**Review of Performance Assessment and Composite Analysis for the Proposed Environmental Management Disposal Facility, Oak Ridge, Tennessee**

# A Review of the Performance Assessment and Composite Analysis for the Proposed Environmental Management Disposal Facility, Oak Ridge, Tennessee

12 October 2020

Figure 1. Copy of R1 PA Figure 5.9; Probabilistic results for 10 sets of 300 simulations.

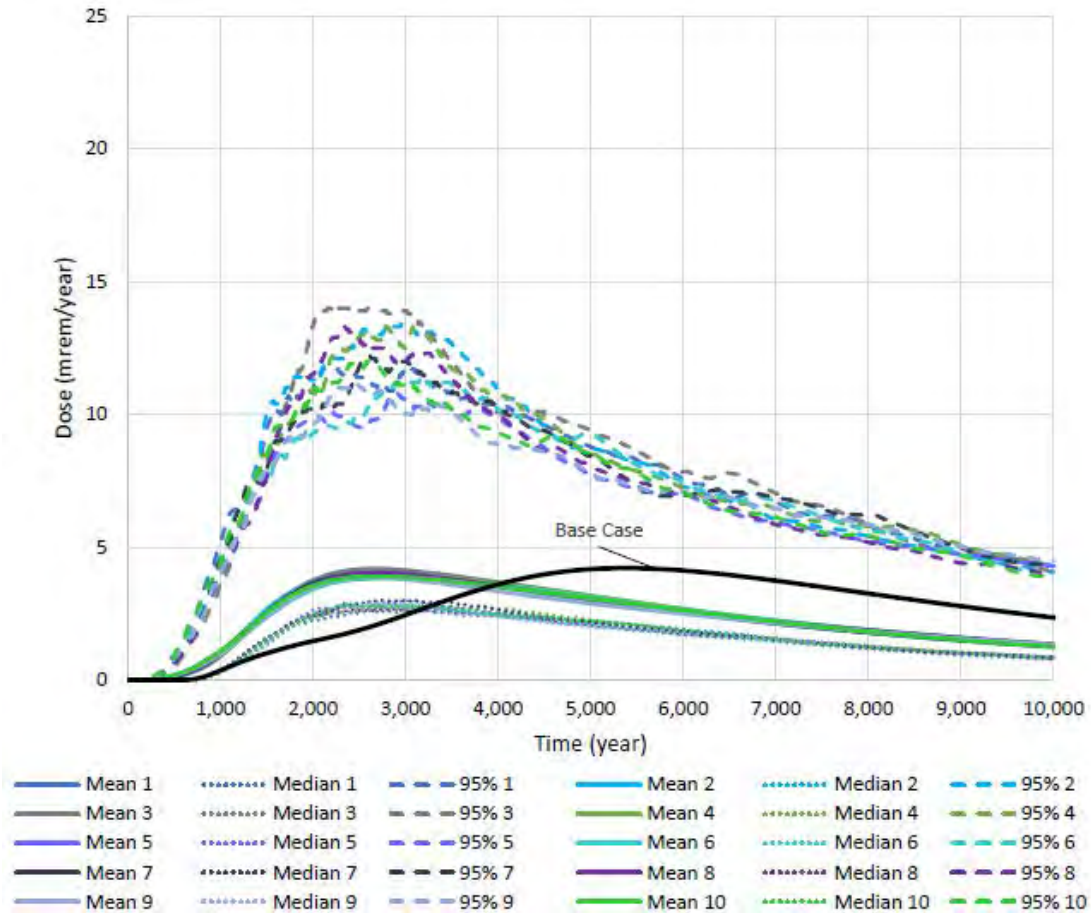
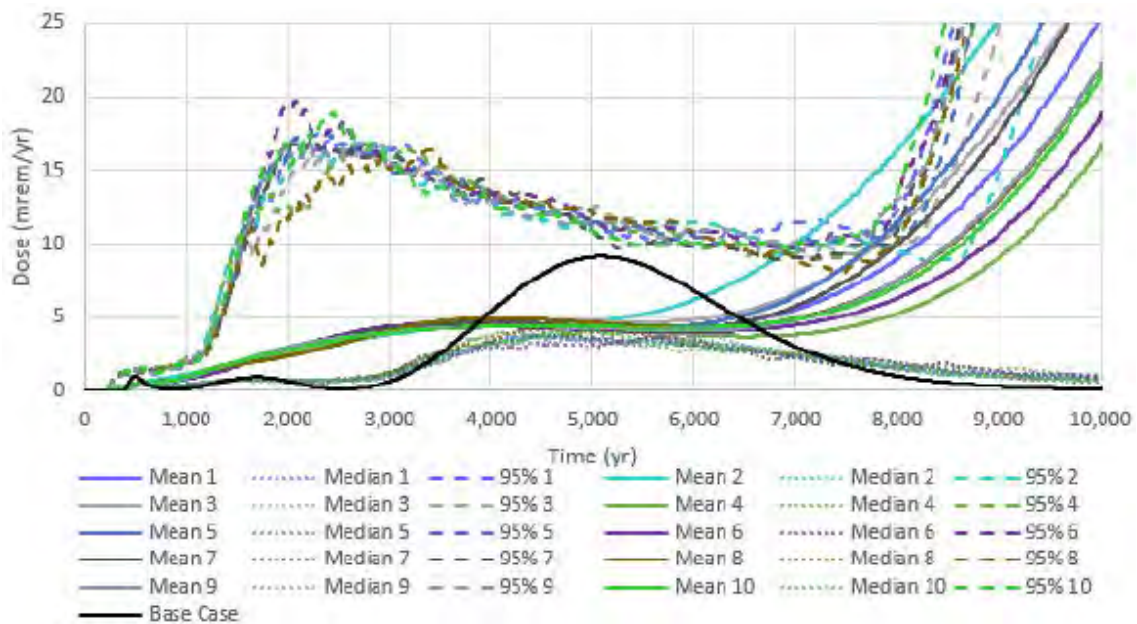
Figure 5.9 of the R1 PA (see Figure 1) indicates that the uncertainty in future radiation dose (measured as the difference between medians or means and 95<sup>th</sup> percentiles) over a modeling period of 10,000 years is believed to be approximately a factor of three. This degree of confidence in the very long-term performance of the EMDF reflects a concern with the PA modeling—the behavior of the system is controlled by assumptions (model boundaries) rather than by mechanistic modeling of all applicable events and processes. As shown in Figure 2 below, in the R2 PA uncertainty in landfill performance increases significantly in the distant future, although degradation of performance is still heavily constrained by the critical assumptions discussed above. Absent such constraints, the timing of potential doses above 25 mrem/yr would be expected to shift to earlier dates.

Over the 10,000-yr modeling period, the difference in all-pathways probabilistic dose results from the R1 PA to the R2 PA is illustrated in the following figures:

The significant increase in the R2 PA 95<sup>th</sup> percentile and mean doses occurs because the dose results after ~6K years are skewed high by very large late-in-time doses in some realizations. Section 5.4.2 of the R2 PA states that the divergence of the medians and means “reflects the strong negative<sup>2</sup> skew that develops in the distribution of total dose after 5000 years, due to a large proportion of very small total doses and a small proportion of very high doses.” The first peak for the 95<sup>th</sup> percentiles is attributed in the text to fission products, and the second to actinoids.

**Figure 3. Leach rate as a function of  $K_d$  in RESRAD-OFFSITE.**

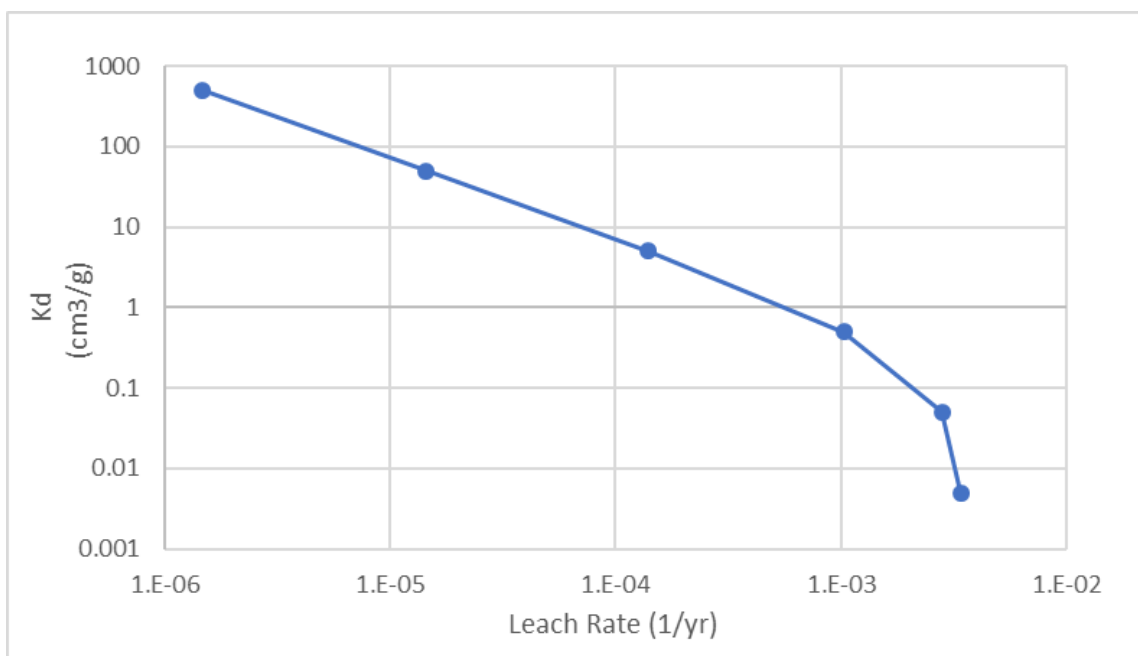
For the R2 PA, the RESRAD-OFFSITE radionuclide release mechanism from disposed waste to the environment was changed from “First Order Rate Controlled Release with Transport” to “Instantaneous Equilibrium Desorption.” In the R1 PA, uncertainty in the leaching rates of radionuclides was evaluated independently of  $K_d$  values, which ignores the strong, non-linear relationship between leaching and  $K_d$  for mobile radionuclides shown in Figure 3. During LFRG review conference calls, OREM and UCOR technical staff explained that the uncoupling of  $K_d$  values and leach rates was due to RESRAD’s inability to calculate leach rate as a function of  $K_d$  value when using the “First Order Rate Controlled Release with Transport” release mechanism.

The Instantaneous Equilibrium Desorption release model in RESRAD-OFFSITE allows for internal calculation of leach rates based on  $K_d$  values. When applying Instantaneous Equilibrium Desorption release, the R2 PA has adjusted the inventory of four mobile radionuclides to reflect an assumption that 100% of radionuclide inventory is available immediately, leading to leaching (presumably, the leached radionuclides are controlled in a leachate wastewater treatment system) of the following fraction of as-disposed inventories of these radionuclides prior to landfill closure (R2 PA Table G.9):

**Figure B 1. Integration of the total water-pathways dose estimates to a hypothetical resident from RESRAD-ONSITE model runs for ~1,000 years following the year of potential geomembrane failure (100, 200, 300 yrs.) and for each  $K_d$  scenario.**

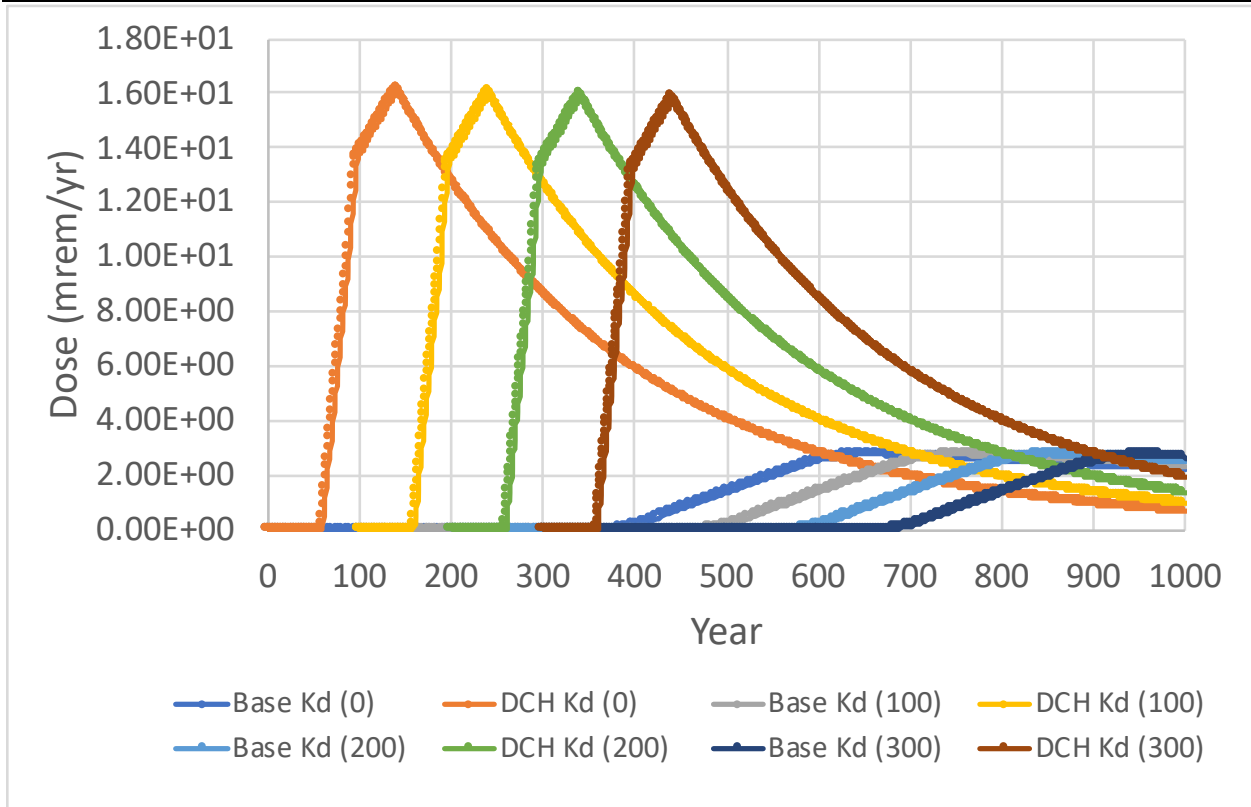
- There is a substantial difference in near-term (<1,000 years) cover performance when substituting RESRAD  $K_d$  values for the base case  $K_d$  values (see Figure B 1 and Table B 1). Although base case  $K_d$  values are lower (less “conservative”) than RESRAD values for most elements, the opposite is true for some relatively soluble elements (H, C, and Tc, as well as U).

Beginning with the concentrations listed in PA Appendix G, Table G.9 (EMDF Source Concentration), a simple ingrowth/decay model was run in GoldSim simulation software to estimate EMDF source term concentrations at 100, 200, and 300 years—three hypothetical time points for potential geomembrane failure. Corresponding concentrations were then entered into the RESRAD-ONSITE model to calculate total dose at time points ranging from 100 to 50,000 years post-site closure. In addition, two different  $K_d$  scenarios were examined for each time point and membrane failure scheme; the two  $K_d$  scenarios take values from the “base case” and DCH lists by element in Appendix G, Table G.11 (Other RESRAD-ONSITE inputs are listed in the appendix of this report.) Figure B 1 displays total dose to a hypothetical receptor at the EMDF for eight scenarios representing four starting inventory concentrations (0, or initial, which used EMDF concentrations listed in Appendix G, Table G.11, and 100, 200, and 300 years, corresponding to EMDF concentration estimates from modeling of nuclide decay/ingrowth at 100, 200, and 300 years, based on the aforementioned initial EMDF concentrations) and two  $K_d$  scenarios (base case  $K_d$  values and RESRAD DCH  $K_d$  values). The results of these RESRAD runs indicate that the time of membrane failure is relatively inconsequential with regards to peak dose and time. Though there is a marked difference in total dose within 1,000 years of site closure between the  $K_d$  scenarios, total dose in each instance remains relatively low (Figure B 1).

**Figure B 2. Integration of the total water-pathways dose estimates to a hypothetical resident from RESRAD-ONSITE model runs for 35,000 years following the year of potential geomembrane failure (100, 200, 300 yrs.) and for each  $K_d$  scenario.**

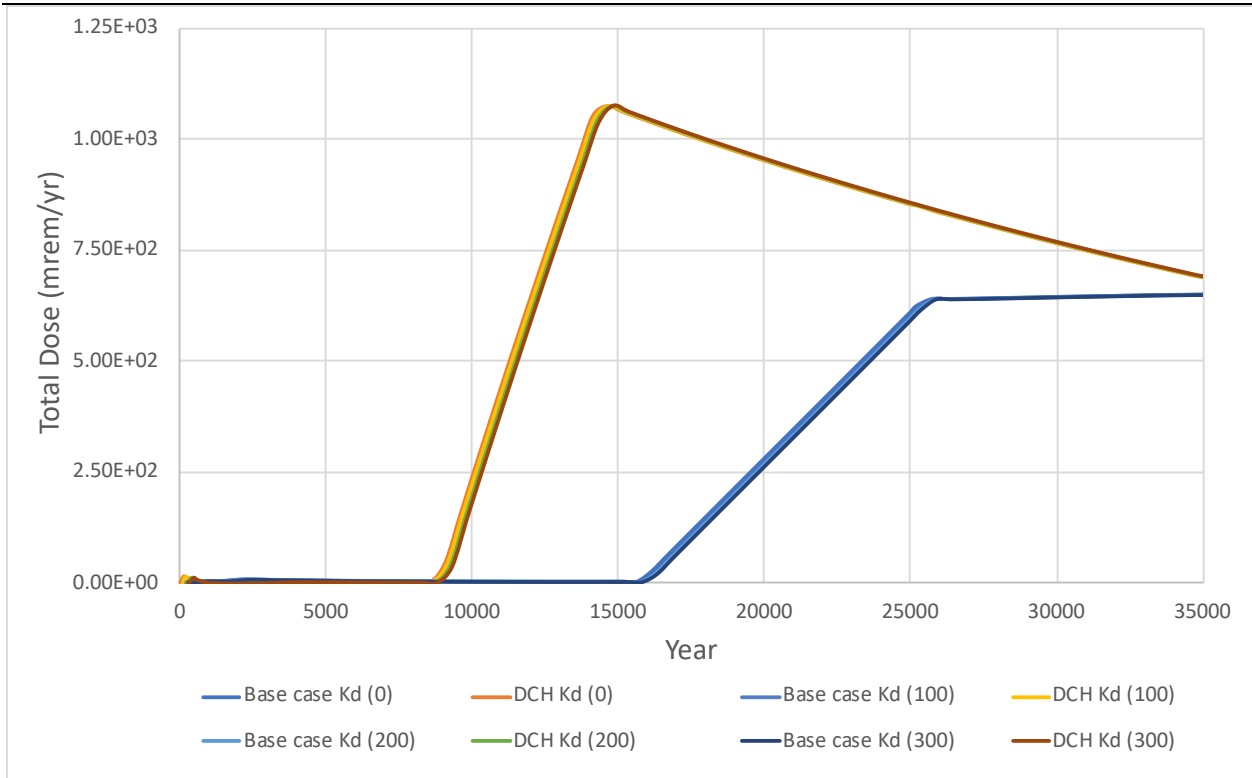
The very long-term contribution (35,000 years) of water-dependent exposure pathways for a receptor situated on the EMDF landfill is shown in Figure B 2. In the base case  $K_d$  scenario, water-dependent pathways dose becomes notable on the y-axis scale around 15,000 years post-site closure, and earlier (about 10,000 years post-site closure) when using the RESRAD DCH  $K_d$  values. The lower  $K_d$  values for C-14, I-129, and Tc-99 in the DCH  $K_d$  scenario result in a peak dose that is larger and arrives sooner than occurs in the base case  $K_d$  scenario. These simulations make clear that the choice of partition coefficients is immensely important, and as shown in Figure B 2, the model predicts that when DCH-recommended  $K_d$  values are used, total dose peaks within 15,000 years post-closure. Note that by approximately model year 25,000, with the assumed 0.000066 m/yr sheet erosion rate (see Section B5.5), more than half of the original cover thickness will have been removed, and cover performance assumptions related to infiltration (1 inch/year) will therefore likely be invalid. For this reason, the estimated doses at times in the very distant future that are shown in Figure B 2 should not be interpreted as predictive of landfill performance and precise total dose. The purpose of simulating landfill performance in the very distant future is to understand the implications of model assumptions on the system behavior, and dose is a convenient metric for integrating such behavior across multiple radionuclides.

**Figure B 3. Comparison of Neptune RESRAD-ONSITE and EMDF PA RESRAD-OFFSITE water-pathways dose over 10,000 years using EMDF PA base case  $K_d$  values with year 200 as the time of geomembrane failure.**

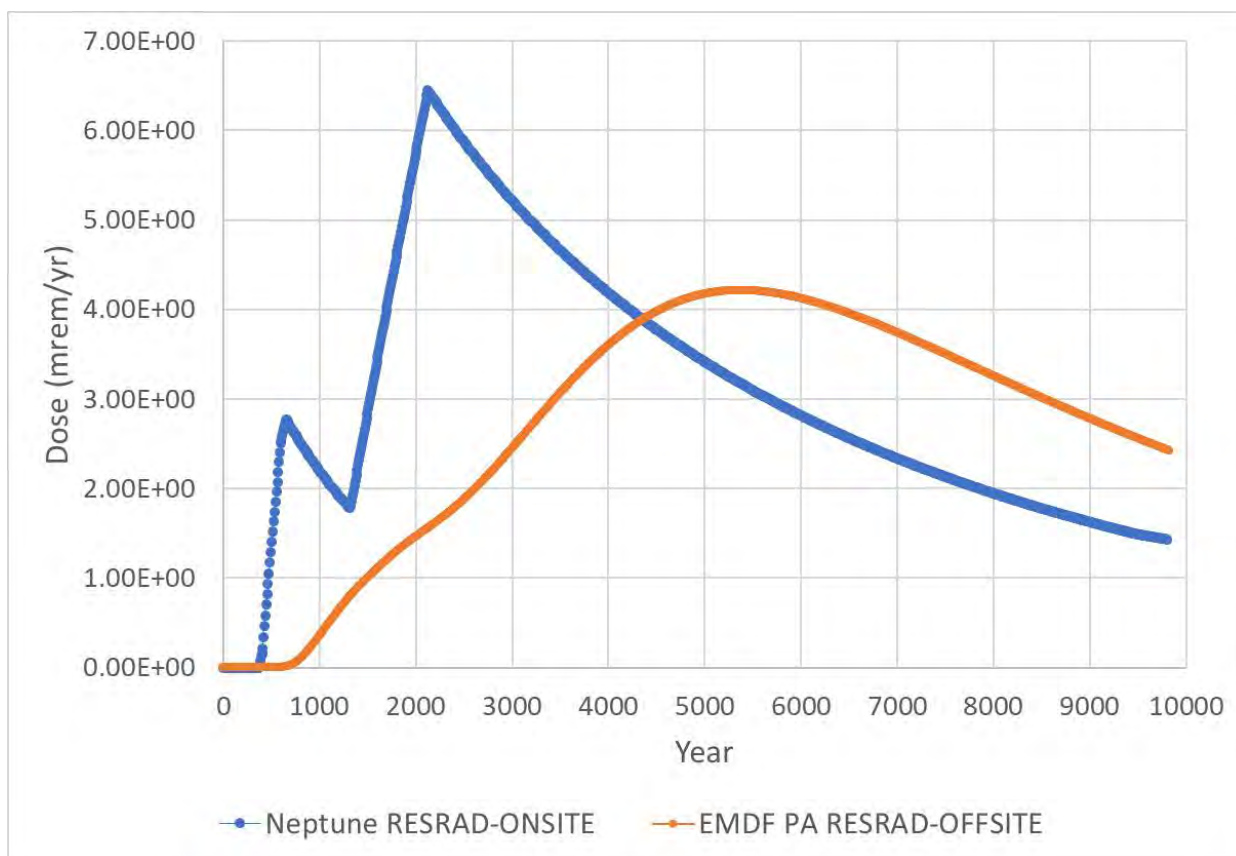
A comparison of the results of the supplemental evaluation Neptune performed using RESRAD-ONSITE and the EMDF PA “base case” results developed using RESRAD-OFFSITE is displayed in Figure B 2. Though the overall radionuclide profile over 10,000 years is relatively similar between the Neptune and the EMDF PA results, the time at which important nuclides, such as C-14, Tc-99, and I-129, begin to contribute significantly to receptor dose differs greatly (Table B 2). Moreover, peak dose in Neptune’s evaluation occurs at approximately year 2,300, more than 3,000 years earlier than in the EMDF PA evaluation (Table B 2). Mobile radionuclides Tc-99 and C-14 are the major contributors to dose for the first ~1,000 years in the RESRAD-ONSITE run (represented by first rise and peak in Figure B 2; at ~600 years they contribute to dose equally, see Table B 2), with I-129 dominating for the next ~9,000 years (represented by the large peak beginning at ~ year 1,200, peaking at year 2,326, and decreasing until year 10,000 in Figure B 3). In contrast, the EMDF PA RESRAD-OFFSITE run indicates that the mobile radionuclides H-3, C-14, and Tc-99 are the largest contributors to dose for the first ~5,000 years, and I-129 does not begin to contribute significantly to dose until ~year 5,000 (Table B 2).

The divergent results of the EMDF PA base case (RESRAD-OFFSITE) and the RESRAD-ONSITE results are driven by several factors. First, as the program names imply, the receptor scenario for the RESRAD-ONSITE run assumes a water well is located on the EMDF landfill,

**Figure B 4. Total doses to a potential receptor from garden soil contaminated by drill cuttings for two  $K_d$  scenarios over ~52,000 years after year 2047.**

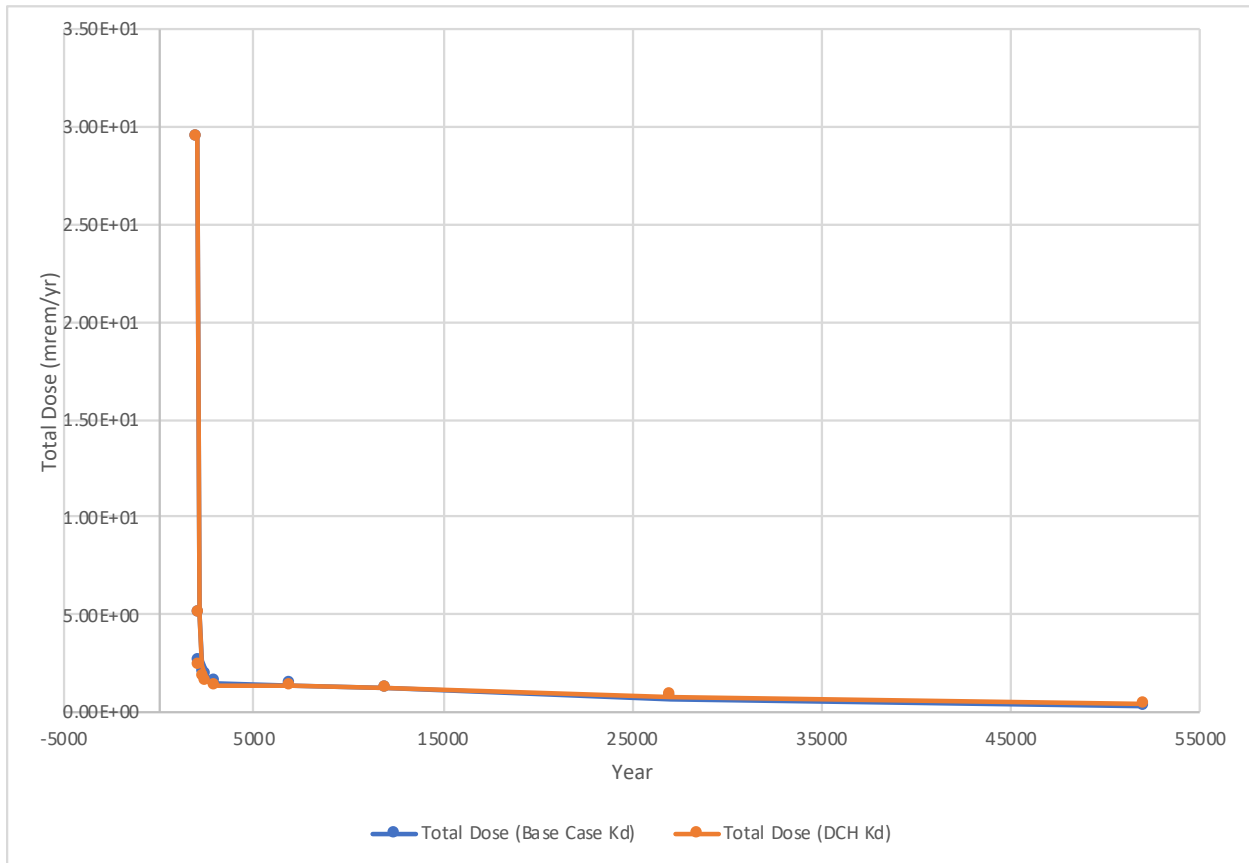
- Drill cuttings dose decreases to levels below a few mrem per year after a few 100s of years as relatively short-lived fission products like Sr-90 and Cs-137 decay (see Figure B 4). Drill cuttings exposures are relatively unimportant for the Chronic Post-Drilling IHI scenario in comparison to the groundwater pathways exposures.

As shown in Figure B 4 below, the results of this evaluation suggest that dose peaks at year 0 and quickly decreases from that time as short-lived radionuclides decay. In addition, there is a negligible difference in dose based on choice of  $K_d$  values, indicating that leaching of radionuclides does not greatly impact drill cuttings dose over time. The drill cuttings scenario shows calculated doses that would result if drill cuttings from a water well that was drilled at any time (shown on the x-axis of Figure B 4) are mixed into garden soil at that time. Whereas the water-pathways doses shown in Figure B 1 and Figure B 2 result from leaching of soluble radionuclides into groundwater, drill cuttings doses are largely independent of radionuclide mobility. In fact, over long periods of time, as more-soluble radionuclides are depleted from the waste zone, only low-mobility radionuclides (those with relatively large  $K_d$  values) remain to contribute to drill cuttings dose.

**Figure B 5. Total dose to a hypothetical resident on the EMDF landfill using waste concentrations corresponding to geomembrane failure at 300 years and an assumed natural recharge/infiltration rate of 8 inches/year following membrane failure.**

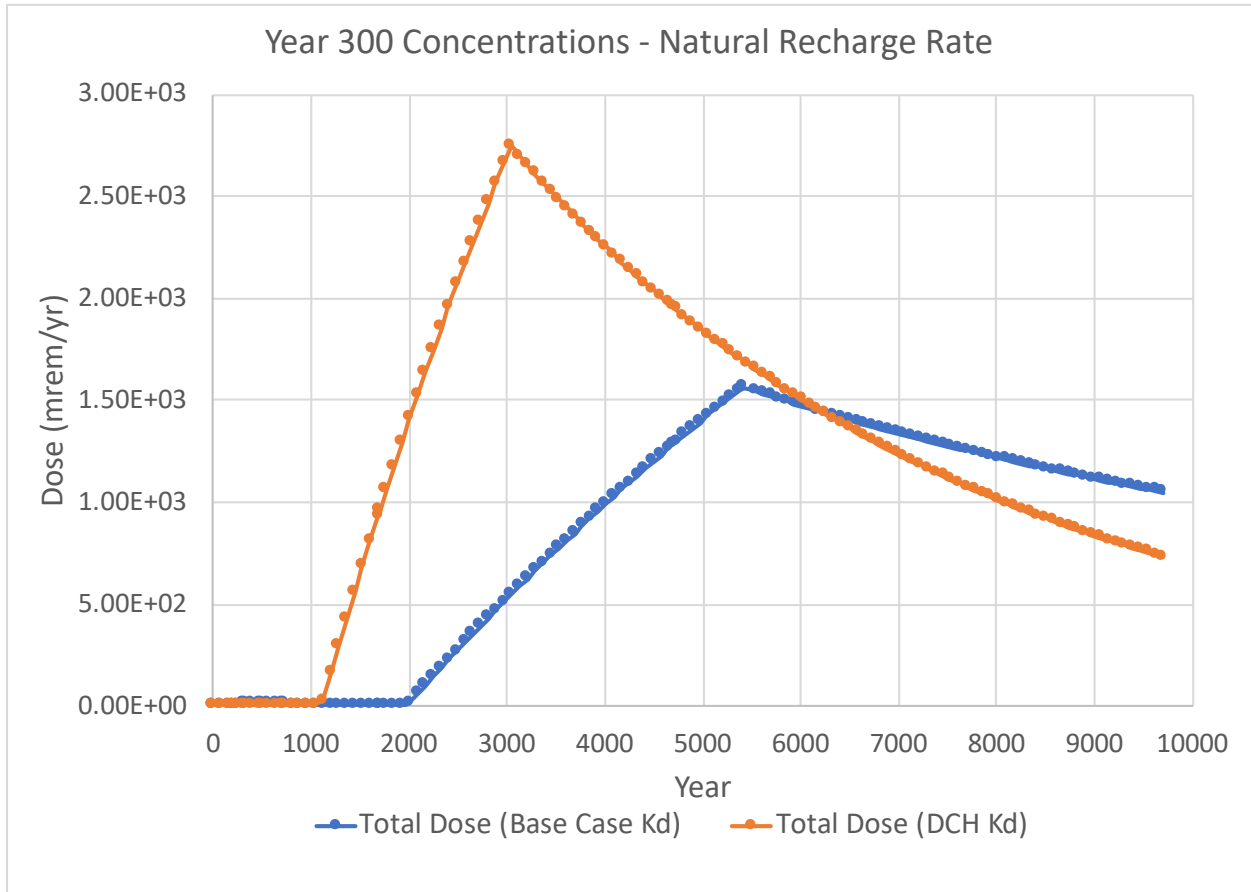
Finally, as a boundary case, Neptune examined a scenario in which, following membrane failure, the site's natural infiltration rate (8 inches per year; PA Section 3.3.1.6) is attained as a result of the liner being compromised from cracking subsequent to differential settling from waste compaction or desiccation during prolonged drought. (Previous model settings described in this evaluation used an infiltration rate of 1 inch per year as a boundary condition.) To test this scenario, Neptune used the estimated EMDF radionuclide concentrations at 300 years (as previously described, these concentrations were derived from ingrowth/decay of radionuclide inventory listed in PA Appendix G, Table G.9), but changed evapotranspiration and runoff coefficient values to achieve an infiltration rate of 8 inches/year (0.203 m/year). The results of RESRAD simulations for this scenario (using two different  $K_d$  cases—EMDF PA base case  $K_d$  values and RESRAD DCH  $K_d$  values) are shown in Figure B 5. Table B 3 contains a detailed breakdown of total dose and important contributing radionuclides at each time point of the different  $K_d$  scenarios.

The findings of this model scenario are significant in that they suggest that, in the case of potential membrane and liner failure, if a natural infiltration rate (8 inches/year) is approached, significant total dose and consequent potential risk to human health in the foreseeable future may result if the  $K_d$  values are close to those suggested in the RESRAD DCH (Figure B 5). The resulting doses are estimated to peak at approximately  $2.7 \times 10^3$  millirem per year after approximately 3,300 years, owing mostly to uranic elements from ~2,000 to 5,000 years in the DCH  $K_d$  scenario (Table B 3). A similar, but delayed radionuclide profile is observed in the base case  $K_d$  scenario, with I-129, C-14, and Tc-99 being the most significant contributors before 5,000 years, at which time uranics begin to dominate, peaking at a dose of  $1.6 \times 10^3$  millirem per year at approximately year 5,700, nearly 3,000 years after the DCH  $K_d$  scenario peak (Table B 3). Importantly, a significant dose on the order of 1,000 mrem/year is estimated at approximately 1,700 years in the DCH  $K_d$  scenario, while the base case  $K_d$  scenario at approximately 1,700 years suggests negligible dose, highlighting significant differences between  $K_d$  scenarios.
